Virgil C. Summer Nuclear Station (VCSNS) Units 2 and 3
Combined License Nos. NPF-93 and NPF-94
Docket Nos. 52-027 & 52-028

Subject: LAR 13-32 Request for License Amendment and Exemption: Liquid
Radwaste System Consistency Changes

Liquid Radwaste System Consistency Changes

Licensing Basis Documents - Proposed Changes

UFSAR Tier 2 Table 3.2-3

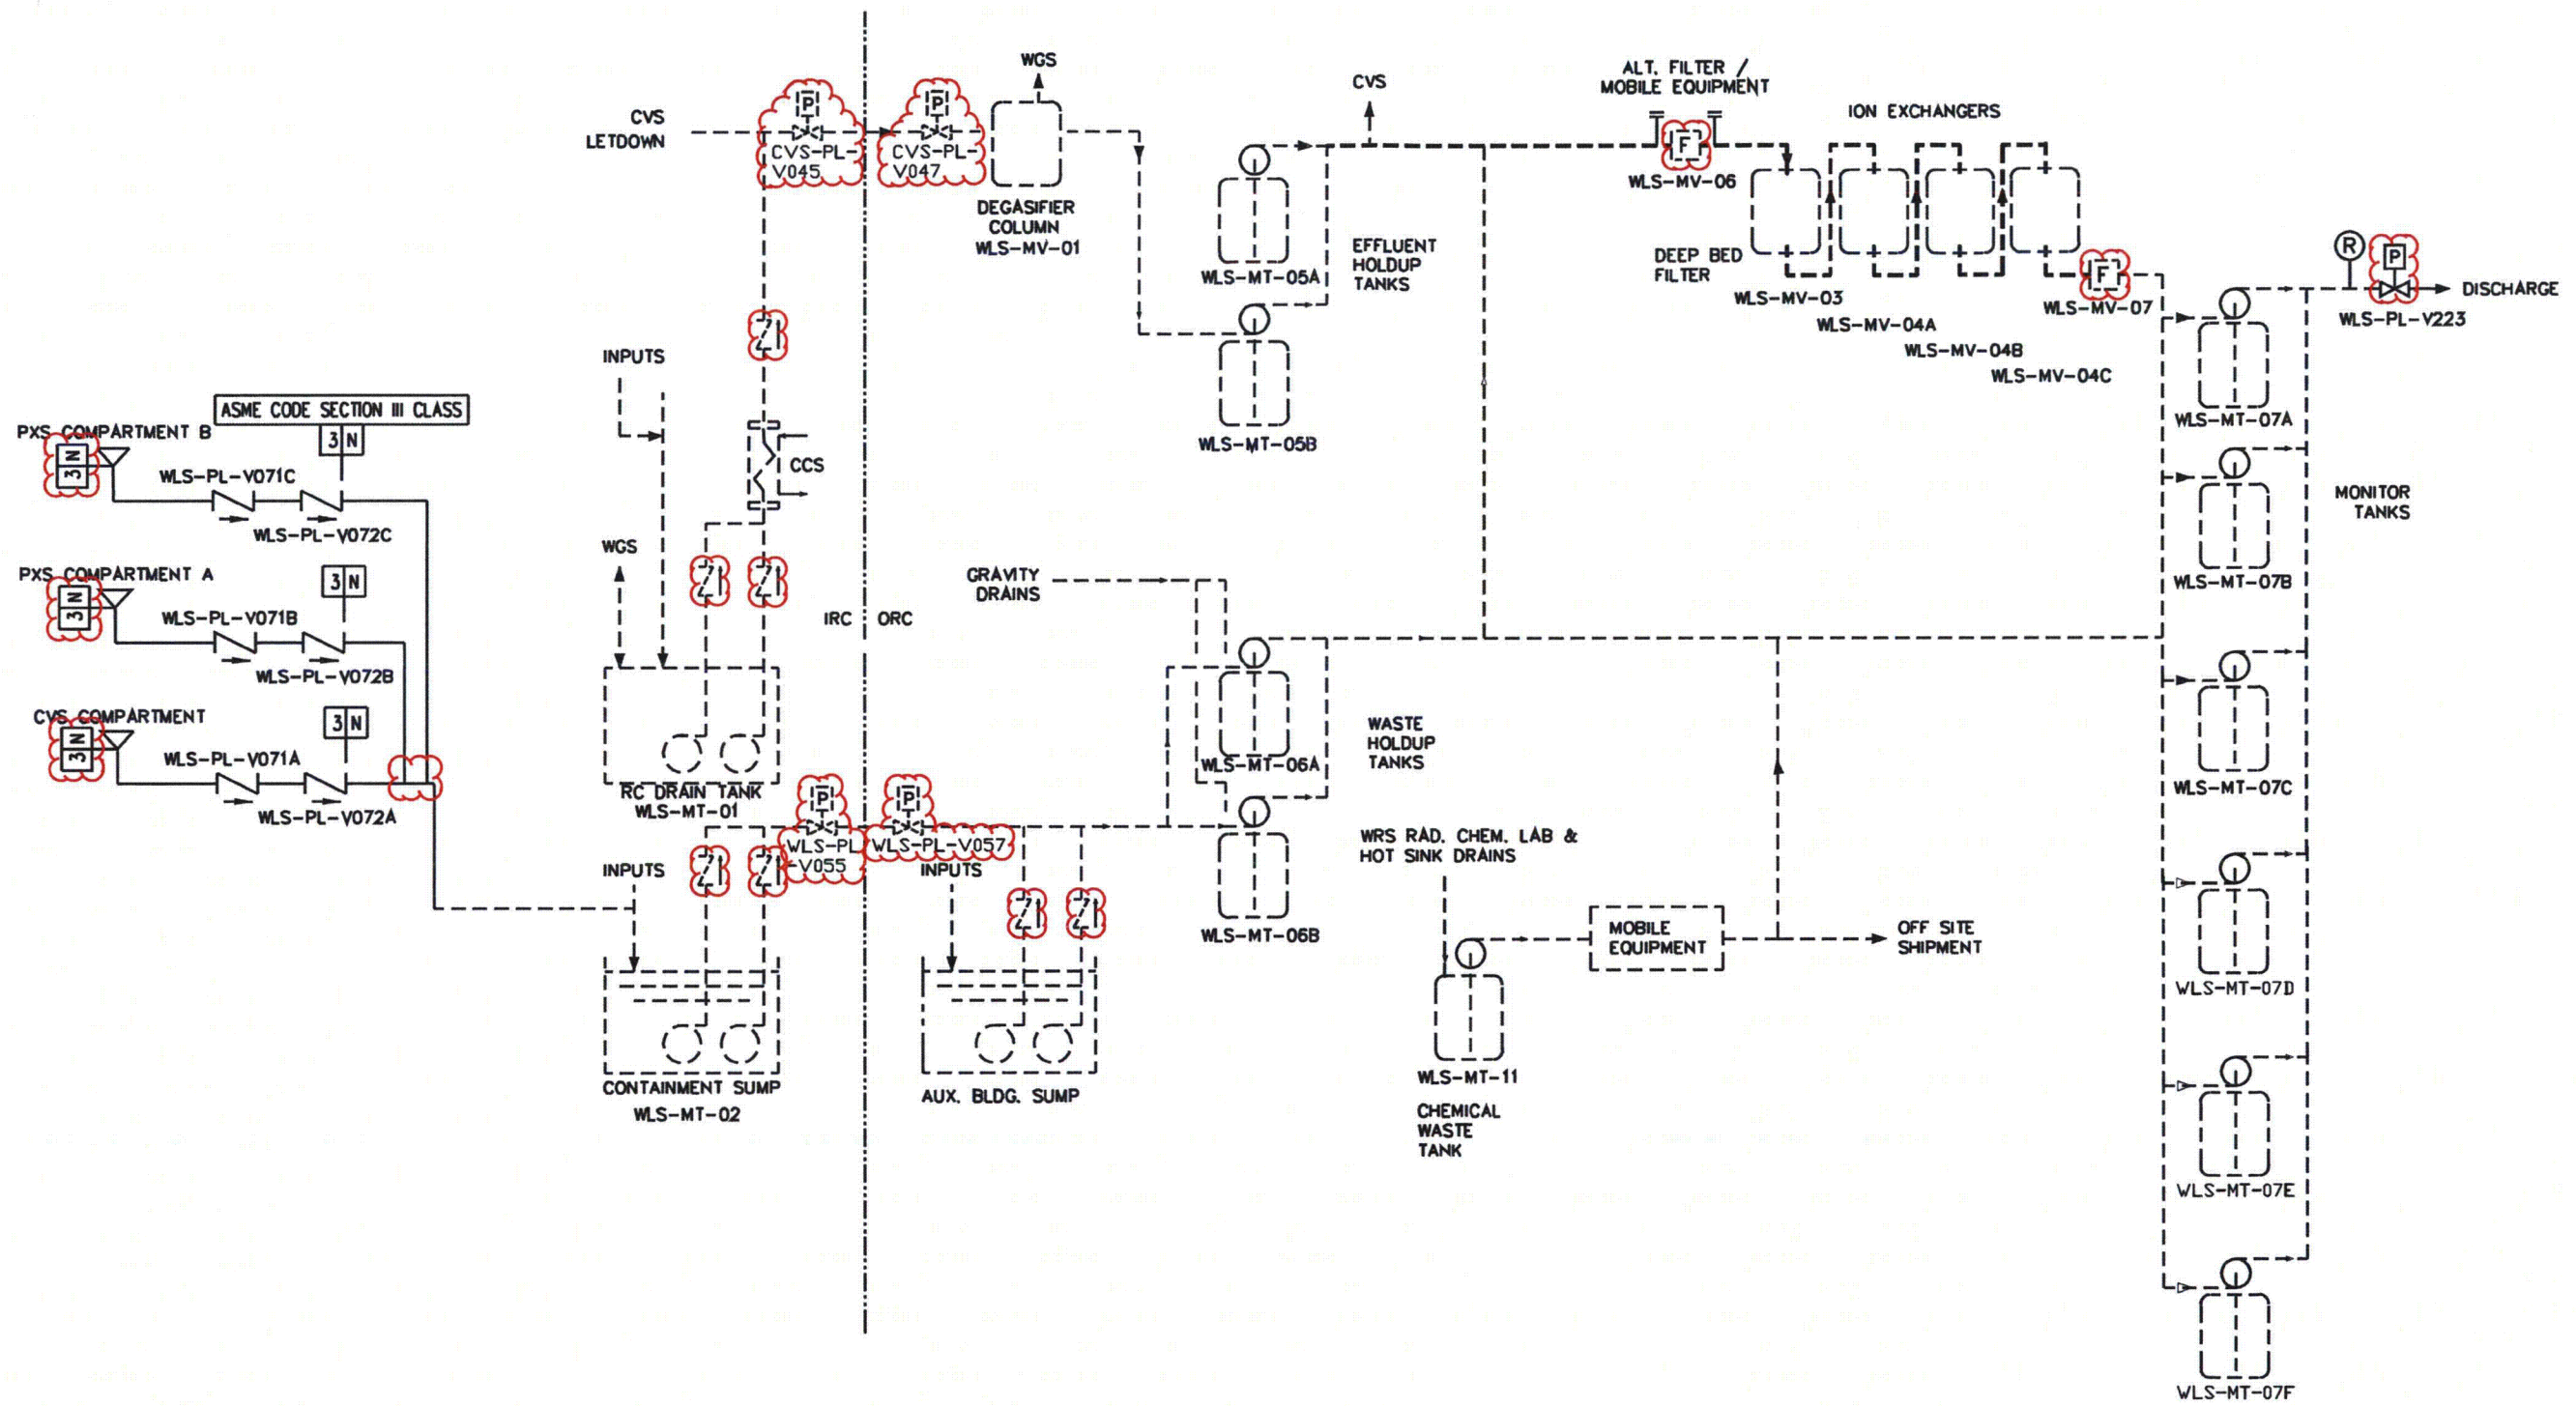
Tag Number	Description	AP1000 Class	Seismic Category	Principal Construction Code	Comments
***	***	***	***	***	***
n/a	Valves Providing WLS AP1000 Equipment Class D Function (local drain valves in Radwaste Building)	D	NS	ANSI 16.34	
<u>n/a</u>	<u>Floor Drain Hubs</u>	<u>D</u>	<u>NS</u>	<u>Manufacturer Std.</u>	
WLS-MT-02	Containment Sump	D	NS	ACI 349	ACI 349 Evaluation of Structural Boundary Only
***	***	***	***	***	***

UFSAR Section 11.2.1.1

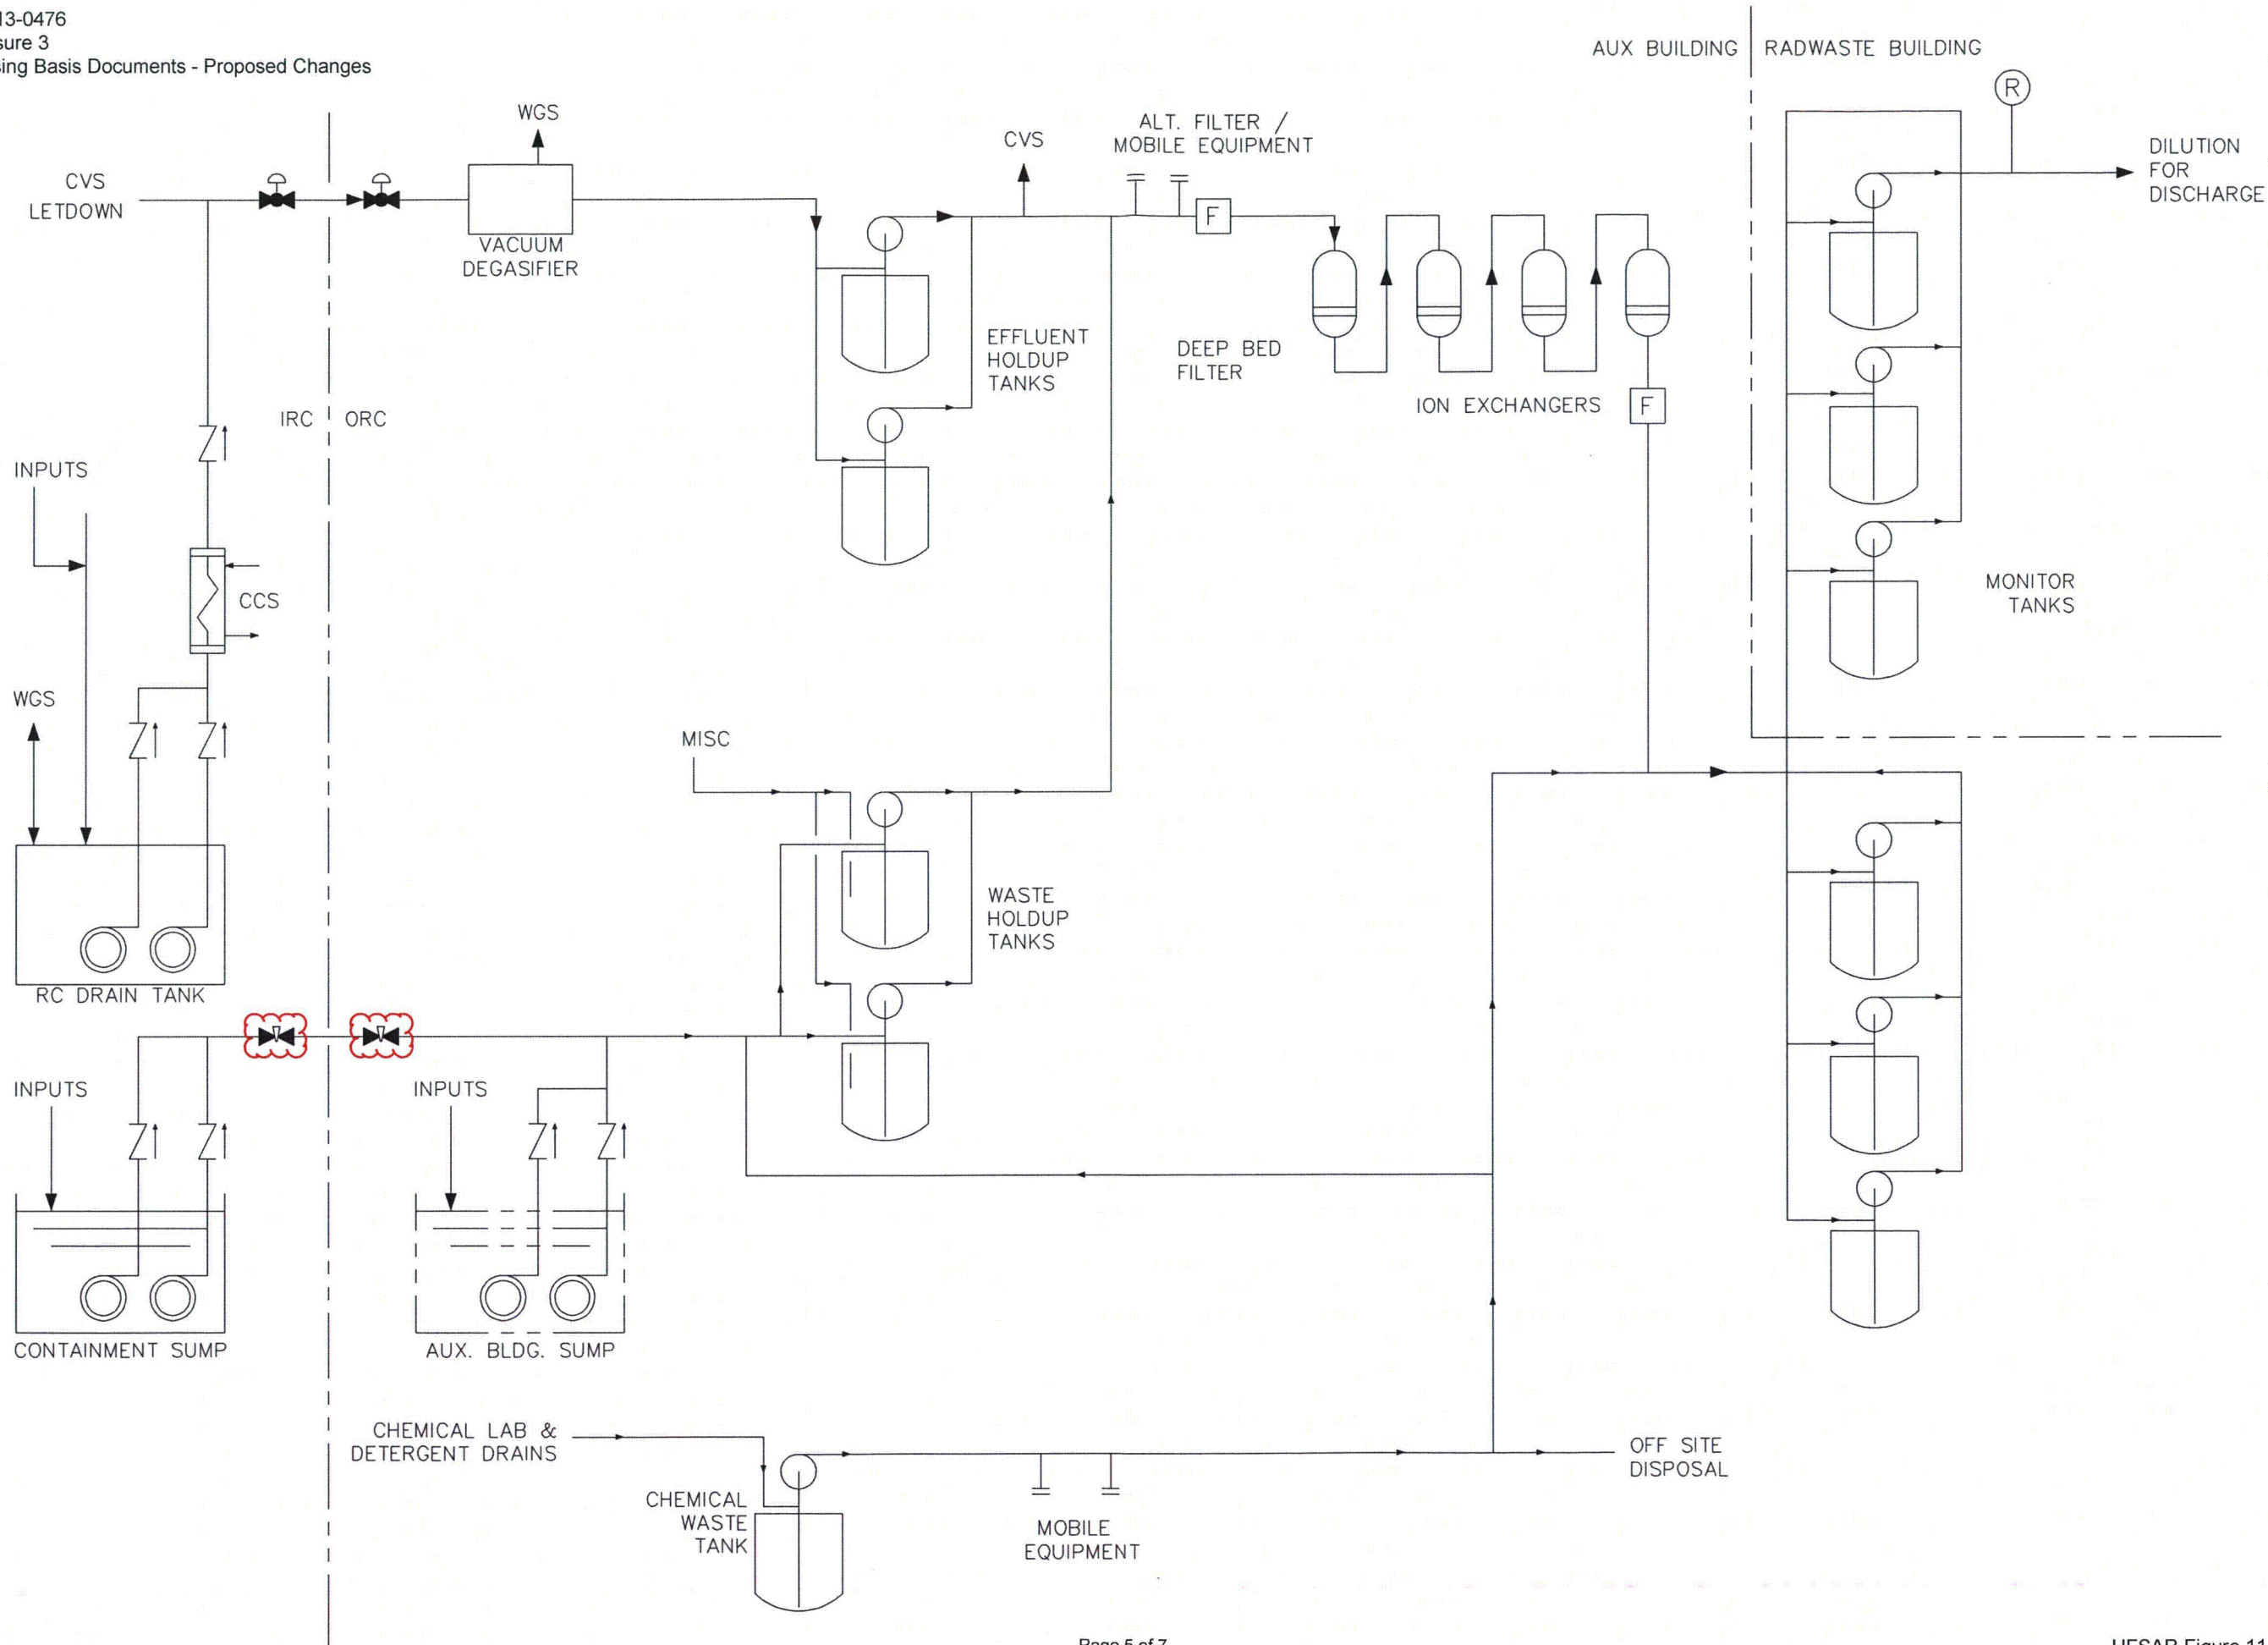
- Containment isolation; see [Subsection 6.2.3](#).
- ~~Draining the passive core cooling system compartments to the containment sump to prevent flooding of these compartments and possible immersion of safety-related components.~~
- Back flow prevention check valves in the drain lines from the chemical and volume control system compartment and the passive core cooling system compartments to the containment sump, which prevent cross flooding of these compartments. Each drain line has two check valves in series so that a single failure does not compromise the back flow prevention safety function. See [Subsection 6.3.3.3.2](#) for a discussion of containment flooding.
